ADDENDUM NUMBER 2 ON INVITATION TO BID ITB19KO-130

TITLE: Sid Martin Biotech Reroof

Addendum #2

1. These five (5) typed pages.
2. Drawing sheets A7.1 & A7.2, revised 6-4-2019.

3 PARAPET DETAIL
A7.1 SCALE: 3" = 1'-0"

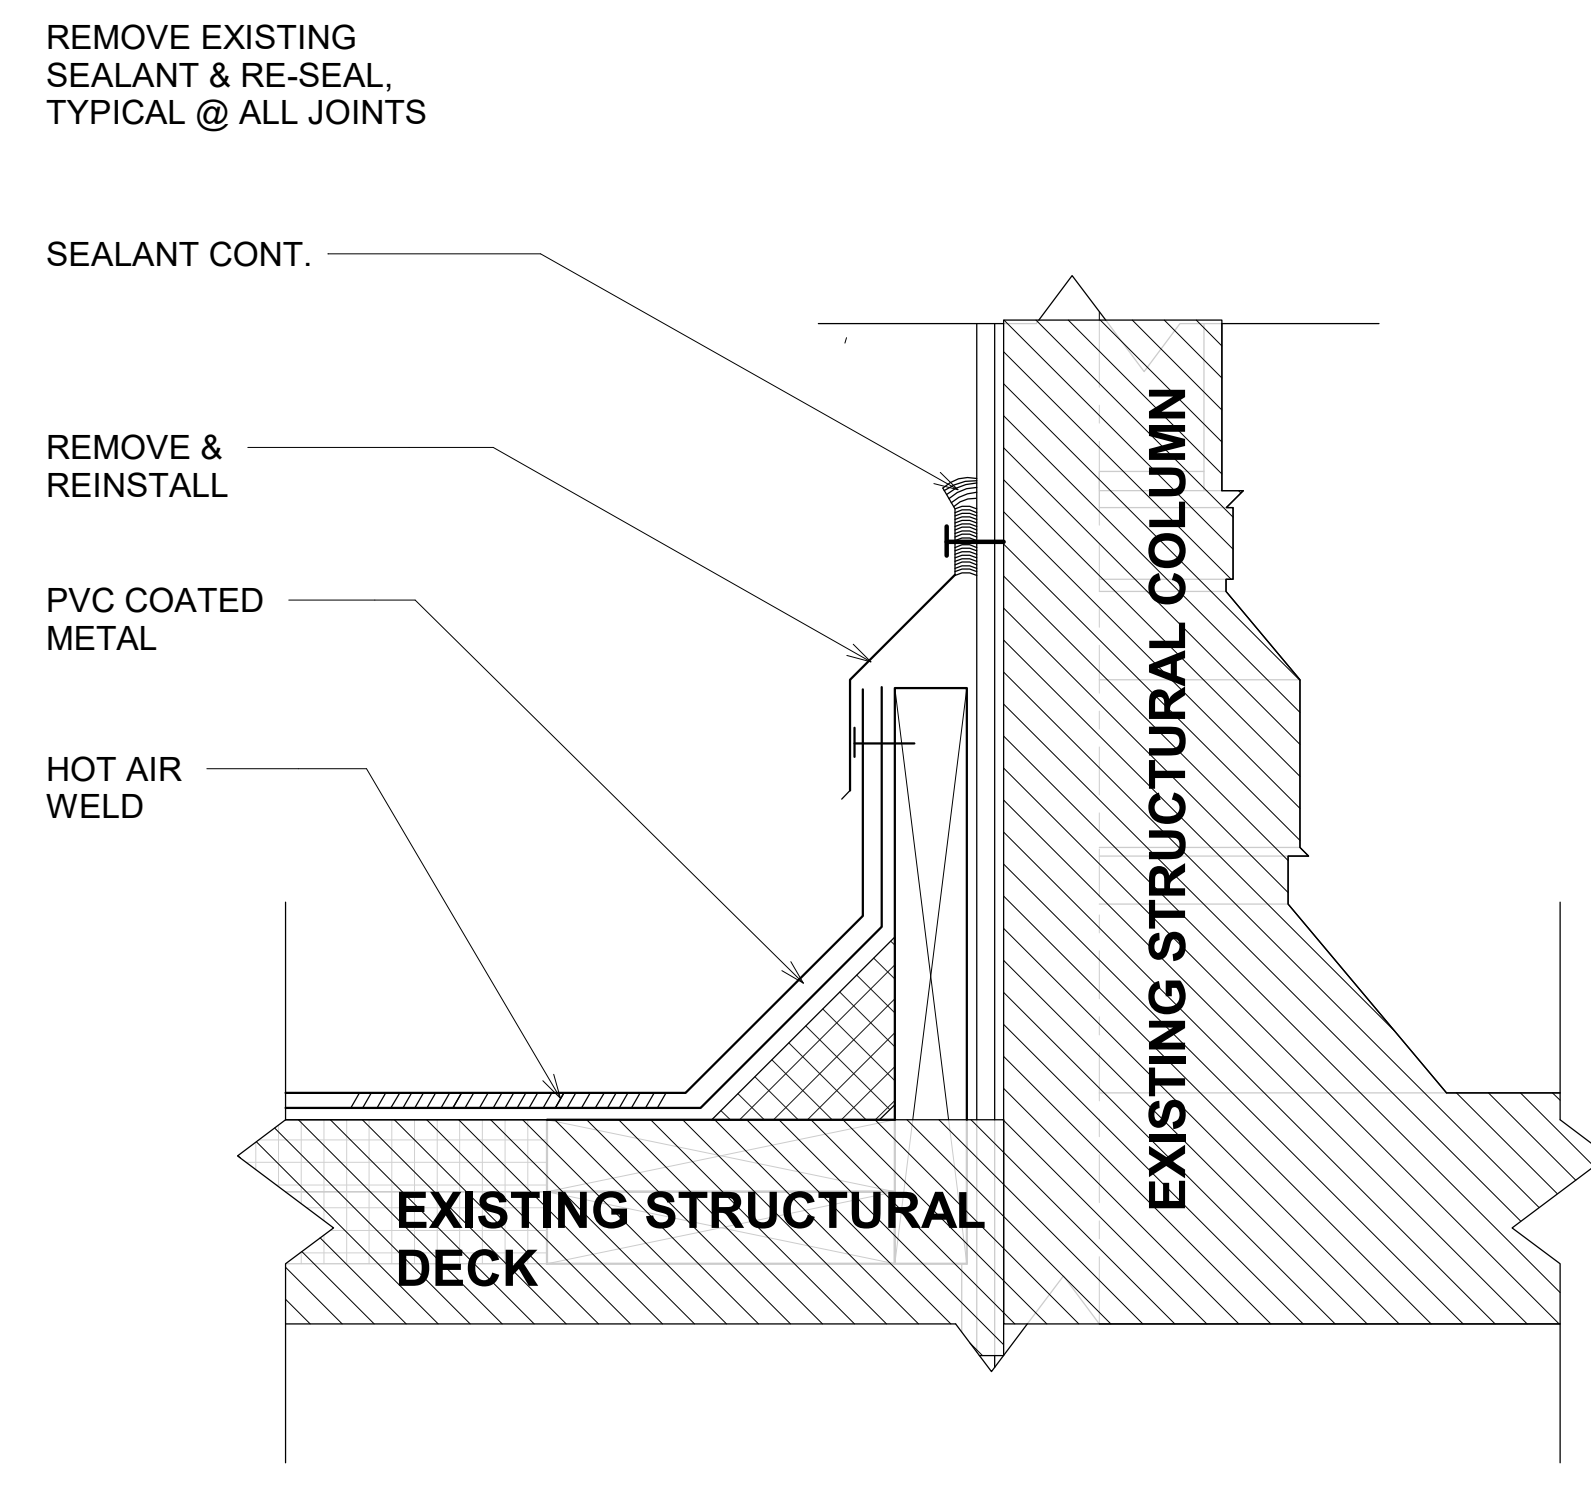
- Q2. Is a performance and payment bond required?
- A2. See Section 00100 – INSTRUCTION TO BIDDERS, 1.9 Performance and Payment Bonds.
- Q3: Can the coping work be clarified?

- A3: Reference attached detail 3/A7.1 revised 6/4/2019. The existing coping will be removed and replaced as indicated on this detail.
- Q4. Specification Section 01000 Scope of Work, paragraph 1. Re-roof.3, calls for installing fall protection system furnished by owner. Please provide information on what system the Owner is furnishing and where it is to be installed.

1 SILLS & CURBS DETAIL
A7.1 SCALE: 3" = 1'-0"

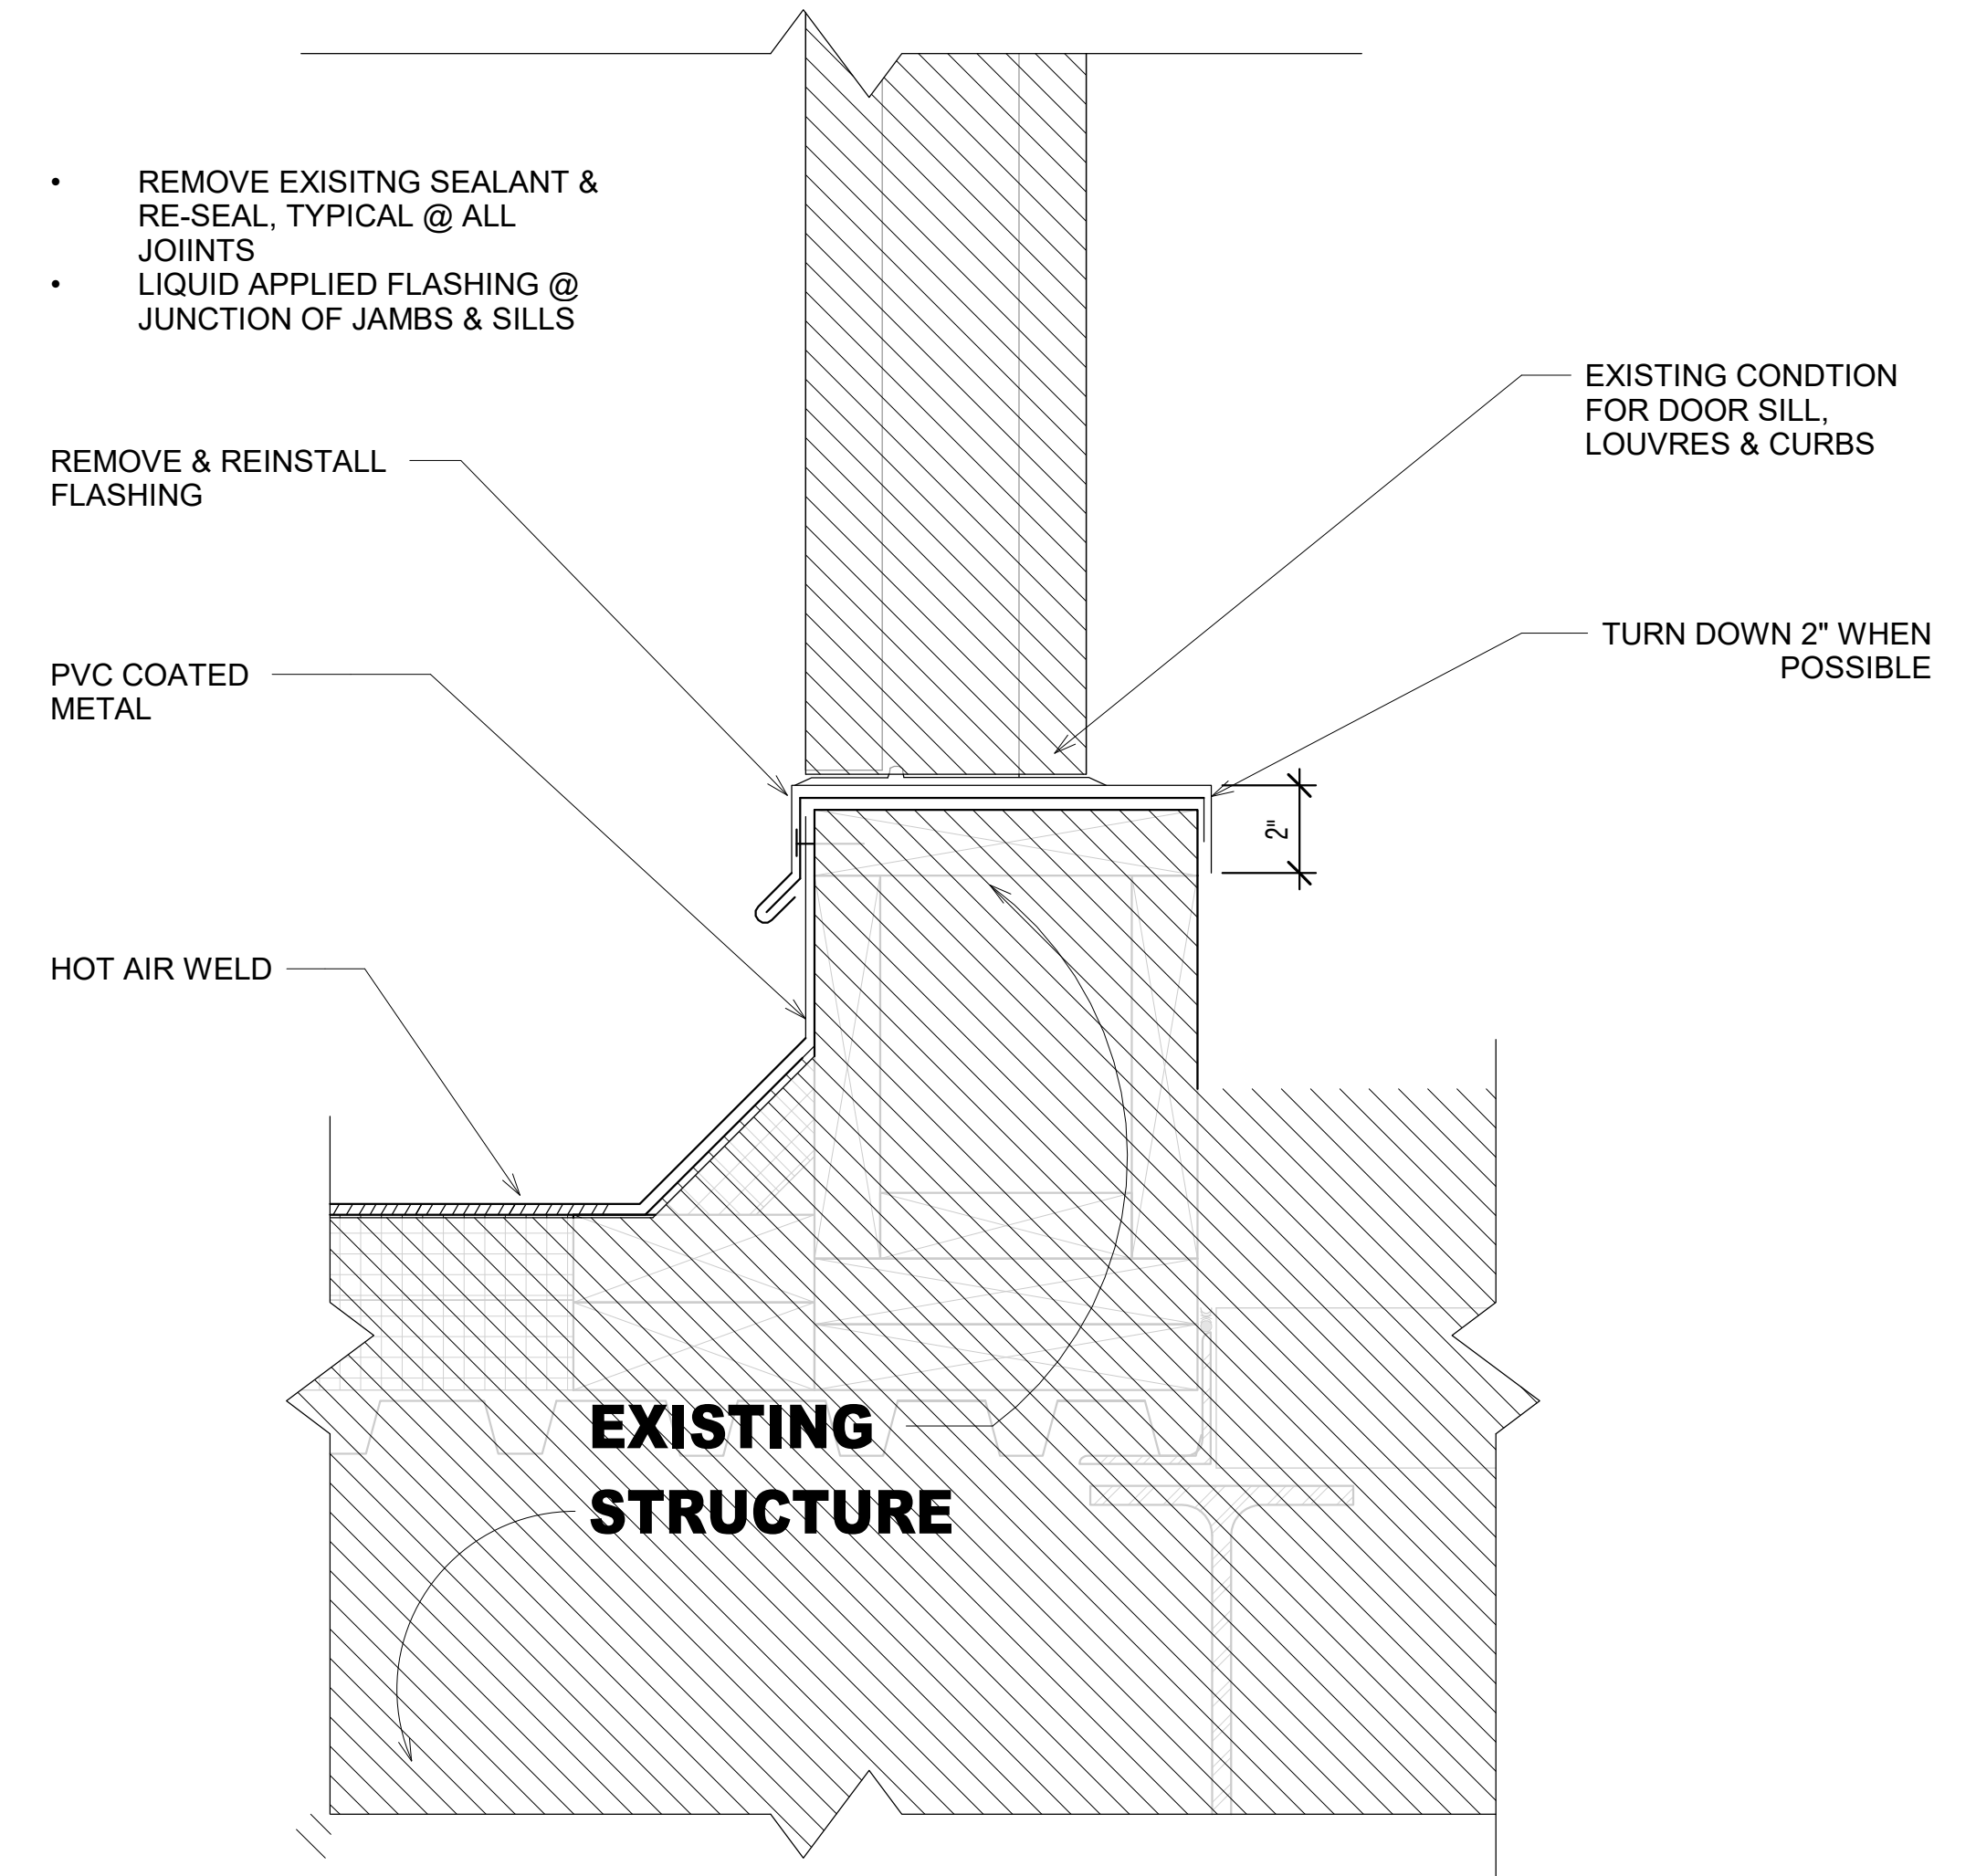
- Q9. Is the existing edge metal of the penthouse to be removed and re-installed?
- A9. Remove and replace flashing only as required to protect new roof membrane. Complete removal and replacement of flashing is only required at the door sill & skylight curb as shown on 1/A7.1

1 ALT. PYRAMID SKYLIGHT DETAILS
SCALE: 1" = 1'-0"

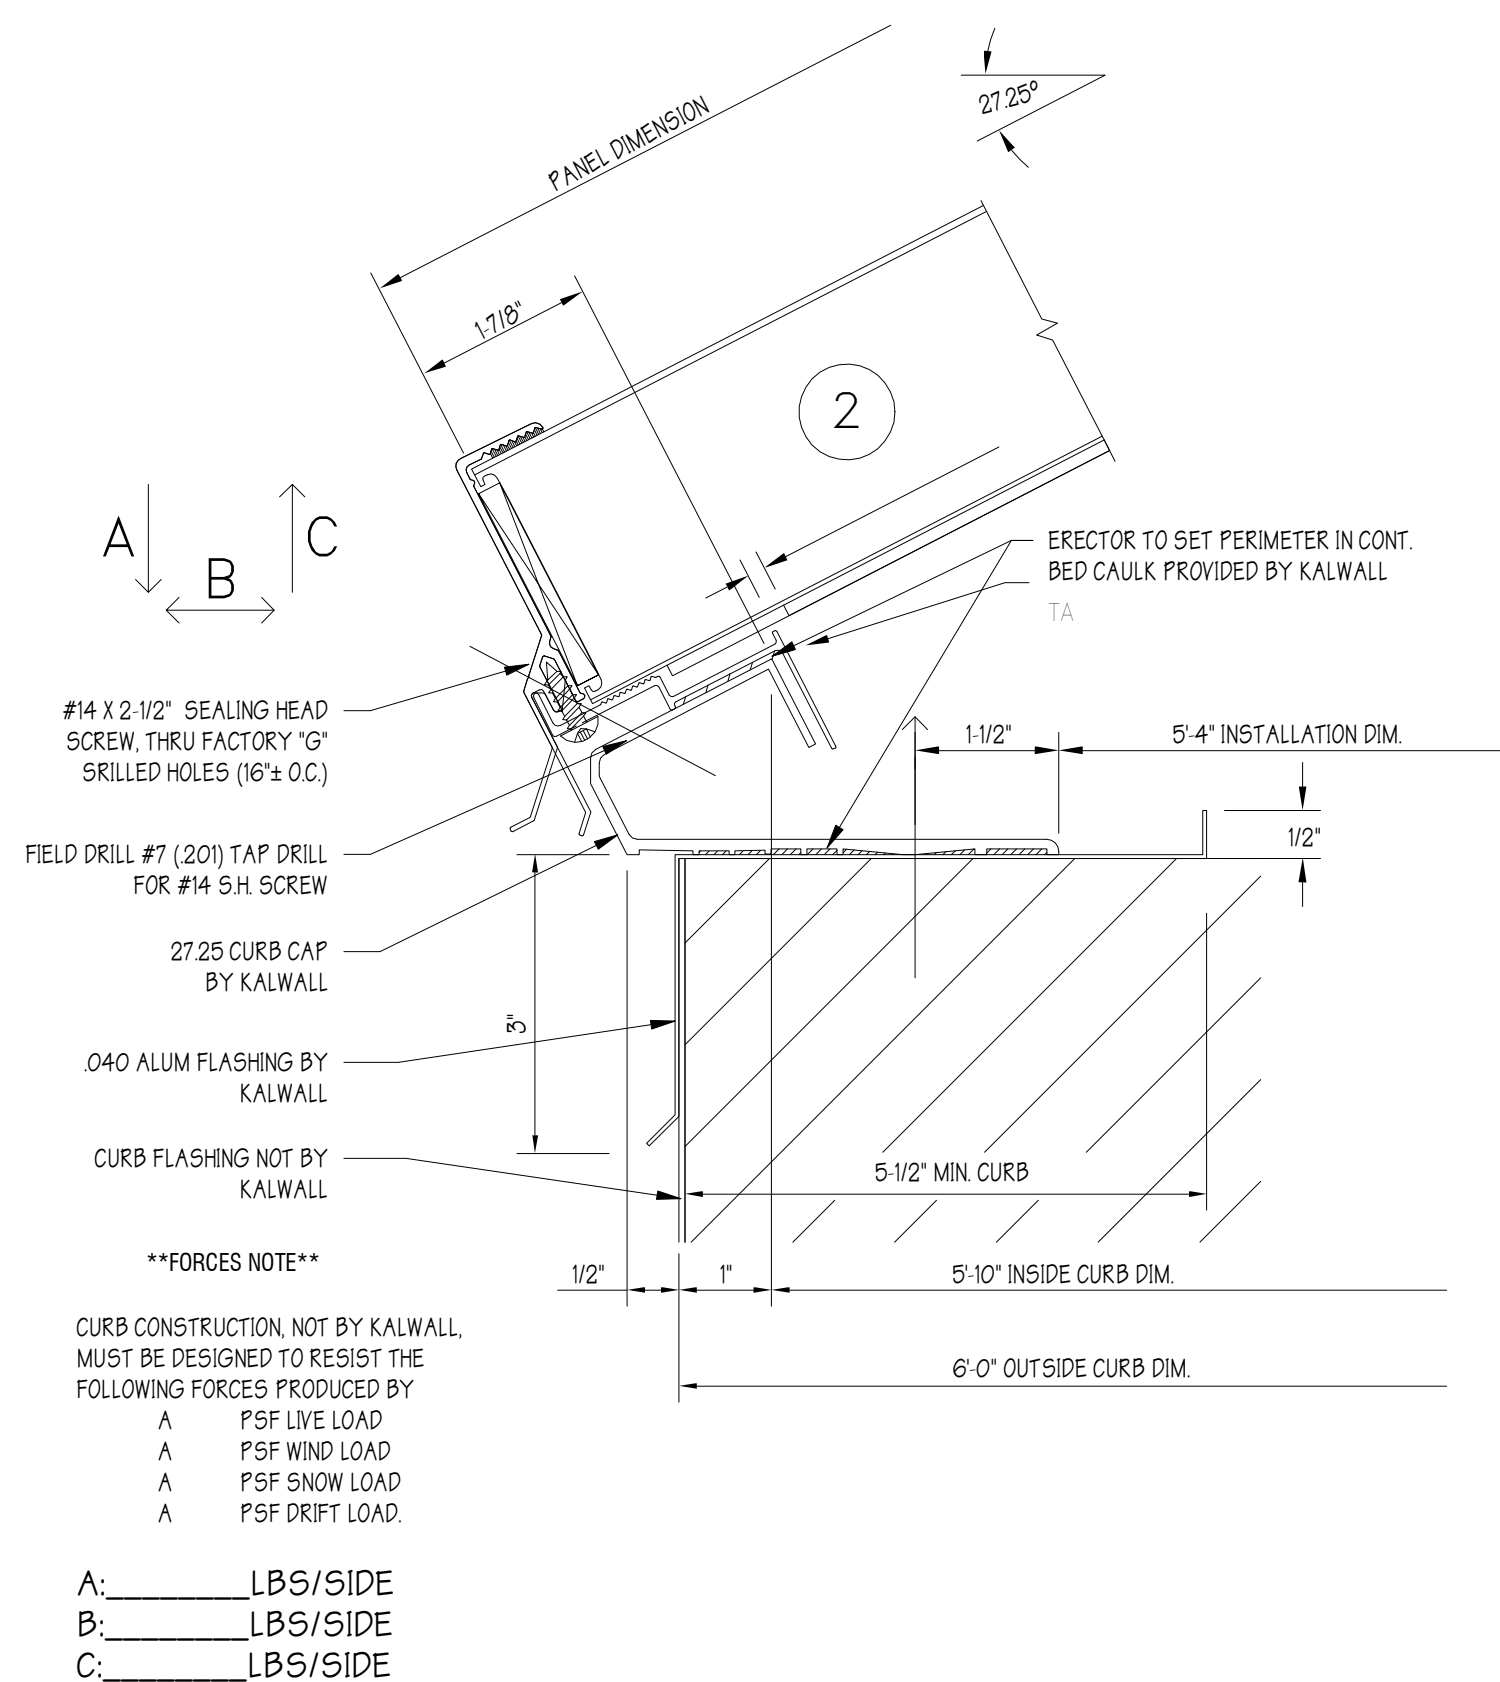
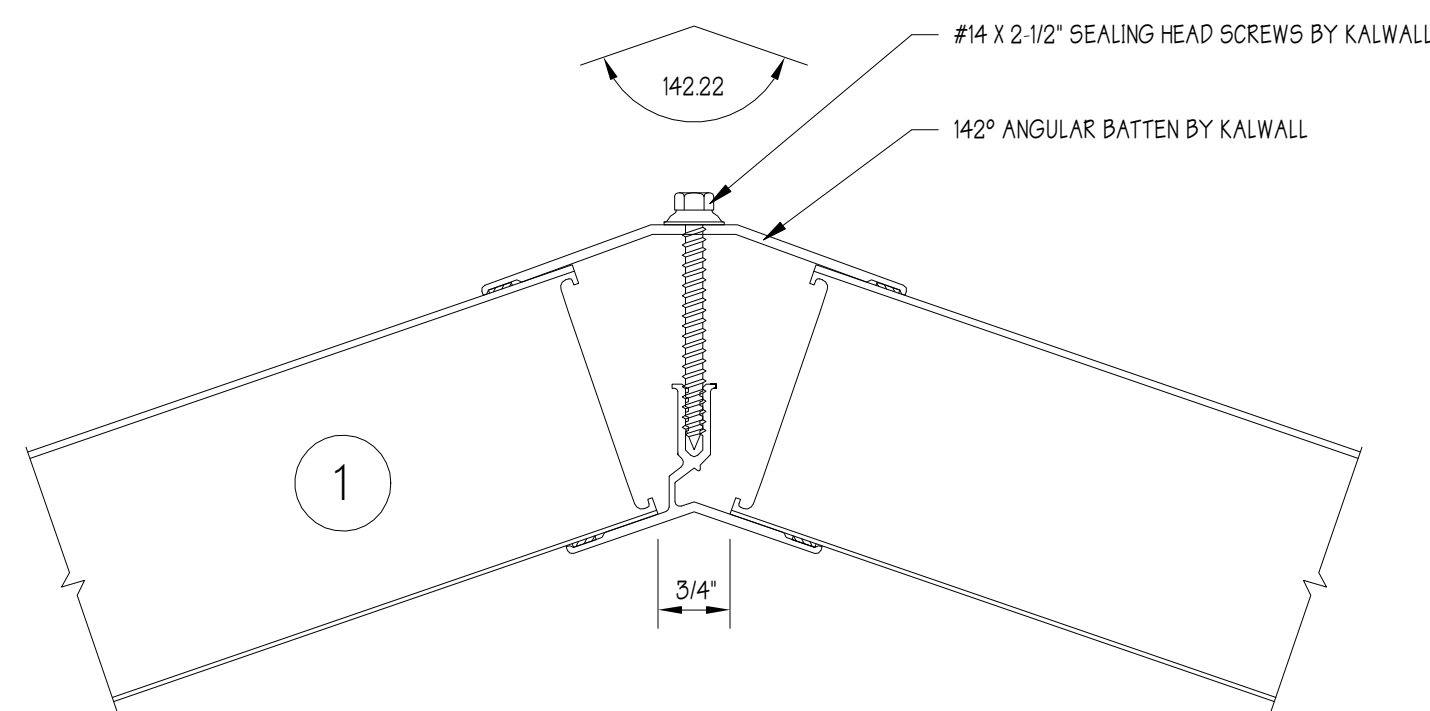
- Q22. The drawings indicate that the new Kalwall skylights are to be 6'-0" square outside curb dimension. At the prebid meeting we measured several of the existing skylight openings and they measured 7'-0" square outside curb dimension. Please confirm dimensions for new skylights?

- A22. The new skylights should be sized to fit the existing curbs. 7'-0" square is acceptable if that works with the existing conditions.
- Q23. In specification section 084523, paragraph 2.2.B, a thermally broken grid core is specified for the skylight panels. This is a cold climate, non-standard option and is not recommended for the hot and humid Florida climate. We strongly recommend utilizing the standard aluminum grid core for these panels.
